PEX 8509

PCI Express Switch

Silicon Revisions and Errata List

Version 1.1

Erratum #4 – Dropped SKIP Ordered Set when Exiting L1 Power Management State

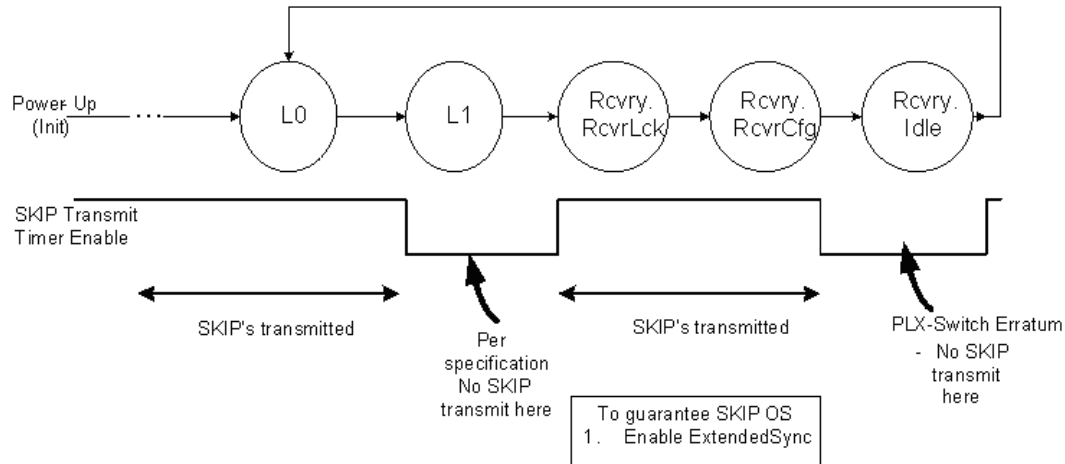
When exiting from the L1 Power Management (PM) state, there is a narrow window (recovery.idle state) during which SKIP ordered sets are not transmitted. The exit from L1 PM state steps through 3 sub-states:

- 1) rcvry.rcvrlock
- 2) rcvry.rcvrconfig
- 3) rcvry.idle.

For the duration in which the link is in Recovery.idle state (waiting for receipt of 8 Idle symbols) there will be no SKIP ordered sets transmitted. Note, SKIP symbols will be transmitted properly when entries into recovery sub-states are from another (L0 or L0s) state.

The Figure below illustrates the behavior.

PCI Express devices whose PHY require SKIP ordered sets to deskew and also to exit the recovery path shown above could fail L1 entry/exit and reach the L0 state >100ms later; consequently, taking the link down along the way. The workarounds listed above can be used to prevent the failing case. Note that when using Workaround 1, the PEX 8509 will not realize any L1 power savings.

One of the following workarounds can be used with upstream devices whose PHYs require SKIP ordered sets to exit its L1 state.

1. Disable the PEX 8509 upstream port's entry to L1 state for ASPM L1 [78h[1:0]] and PCI PM (device specific offset 1E0[7]) mechanisms.
2. Enable the ExtendedSync mode (Offset 78h[7]), to guarantee SKIP ordered sets in the RcvrLck and RcvrCfg states (shown above)
